# UNITED STATES PATENT AND TRADEMARK OFFICE

APPLICATION NO.	FILING DATE	FIRST NAMED INVENTOR	ATTORNEY DOCKET NO.	CONFIRMATION NO.
09/960,306	09/24/2001	Donald Richard LaCoy	20272/0688	5354

**Office Action Summary**

### ***DETAILED ACTION***

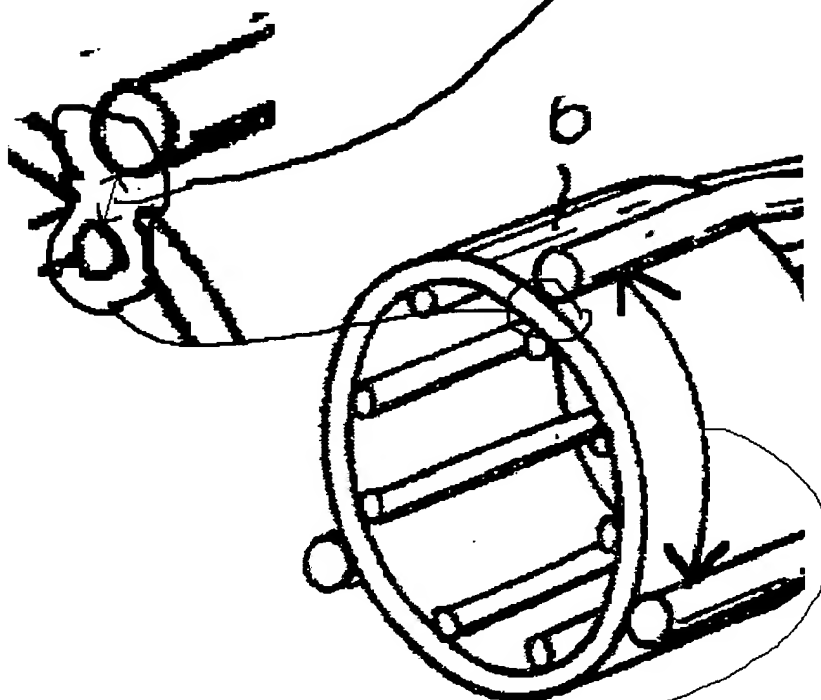
-- In reference to claims 3 and 11, the socket includes three groups of two wires each (see examiner's figure) .

wherein a circumferential spacing of the wire in each group is closer than  
(circumferential spacing means spacing between circumferences)

Examiner's note

wherein the circumferential spacing between each adjacent pair of groups is free  
of any wires.

The second circumferential spacing is about the  
outside circumference of the retaining structure

Examiner's note
